## MEMORANDUM

**Subject:** SR 202, Sammamish River Bridge Widening Project  
SEPA Checklist, Supplemental Information

OPTION No 1  
TEH  
9/26/12

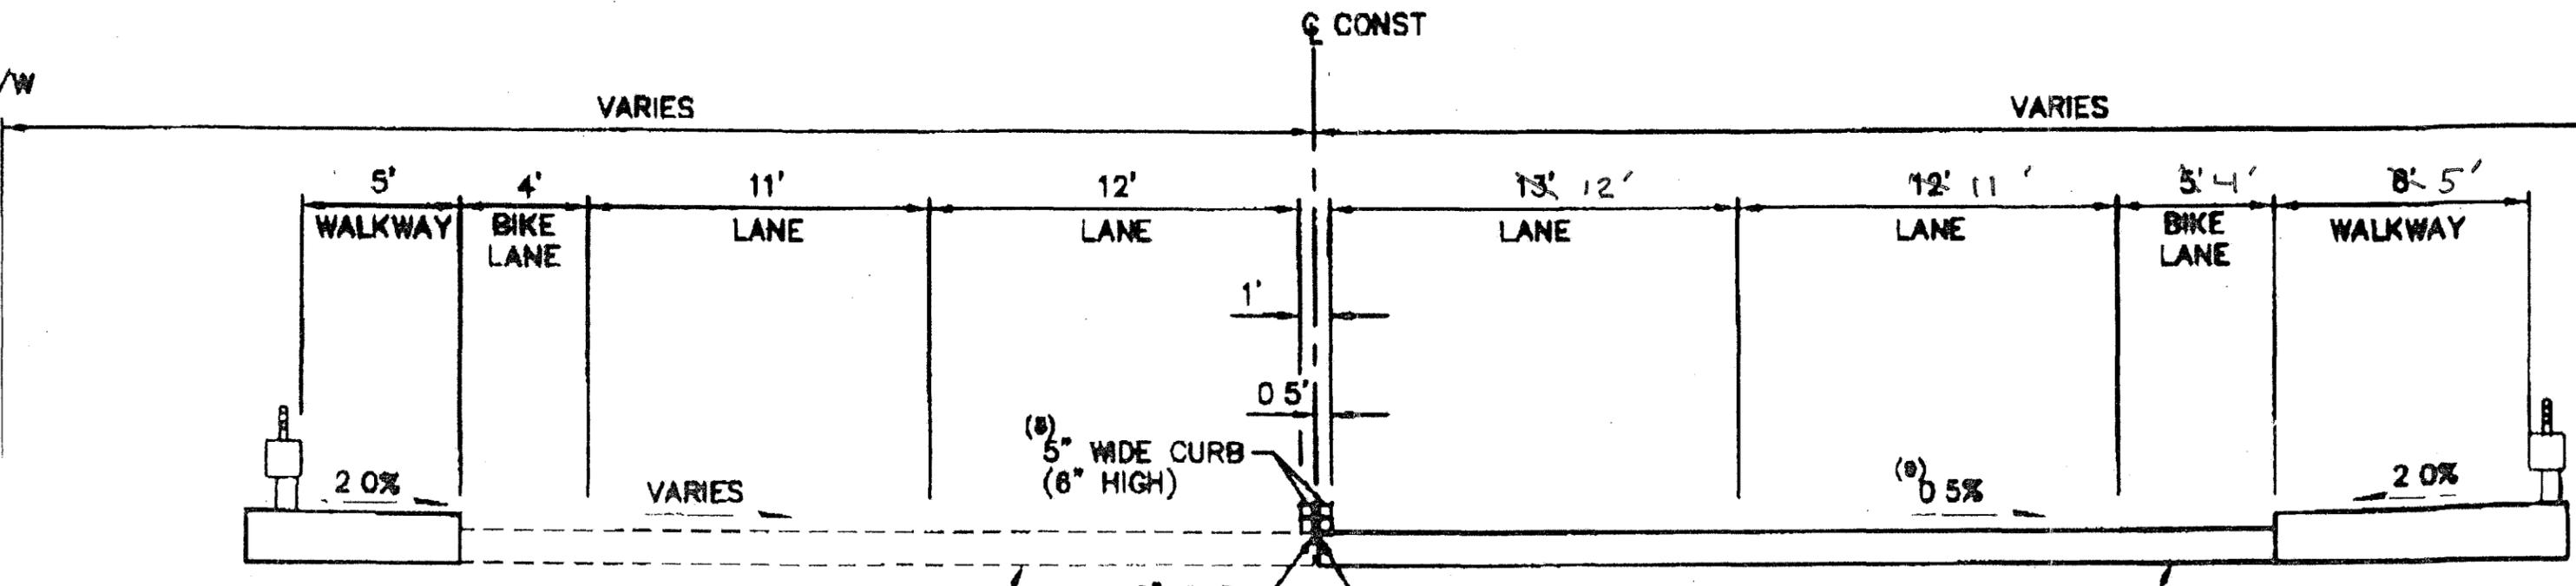
Keeping the east abutment (east end) of the proposed widen bridge at its current location, the bridge widening would be reduced to provide only two, eleven foot lanes, with a one foot shy distance against curbs, and a five foot wide sidewalk. This is shown on the attached roadway section sheet labeled as Option No. 1. No bike lane across the bridge would be constructed. Bicycles would either have to share/use the right travel lane with vehicular traffic, or use the sidewalk. This option has received technical approval from the Port of Seattle in August 2012 as meeting their stated clearance requirements.
